Access Compliance Report

Public Rights-of-Way

(Curb Ramps)

Intersection ID: 8113	Main Street: ORR_RD	Cross Street: GRIER_RD	Location:	N
ADA ID: 08F142D79DAE	Ramp Type: Perp	Initial Pass/Fail: Fail	Overall Compliance: No	Severity Score: 26.25

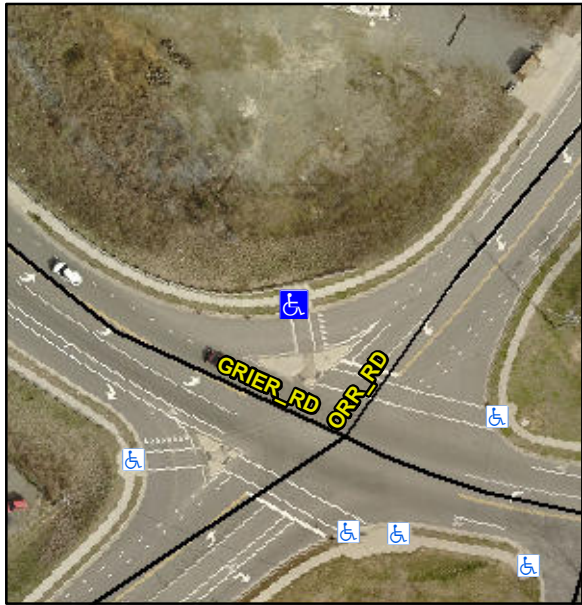
Codes/Mitigation Info/Possible Solution			Field Measurements/Component Compliance					
	Possible Solutions:		Remove & Replace Entire Ramp.					
	Surveyor Notes:		N/A					
	PROW/ADA:		Not Found, R304.2.2, R304.5.3					
	Total Cost:		\$ 1850.00					
	Street 1 Name		ORR RD					
	Stop Condition-Street 2		YieldSign					
	Street 2 Name		N/A					
	Stop Condition-Street 1		N/A					
			Compliance	Description	Data	Compliance	Description	Data
			N/A	Ramp Length (in)	47.5	No	Ramp Slope (%)	12.3
			Yes	Ramp Width (in)	48.0	No	Ramp XSlope (%)	3.1
			N/A	Flare Type LT	N/A	N/A	Flare Type RT	N/A
			N/A	Flare Slope LT (%)	N/A	N/A	Flare Slope RT (%)	N/A
			N/A	Flare Traversable LT?	N/A	N/A	Flare Traversable RT?	N/A
			N/A	Landing Length (in)	N/A	N/A	DWS Provided?	N/A
			N/A	Landing Width (in)	N/A	N/A	DWS Contrast?	N/A
			N/A	Landing Slope (%)	N/A	N/A	DWS Length (in)	N/A
			N/A	Landing X Slope (%)	N/A	N/A	DWS Full Width?	N/A
			N/A	Landing Curb? (Y/N)	N/A	N/A	DWS Offset (in)	N/A
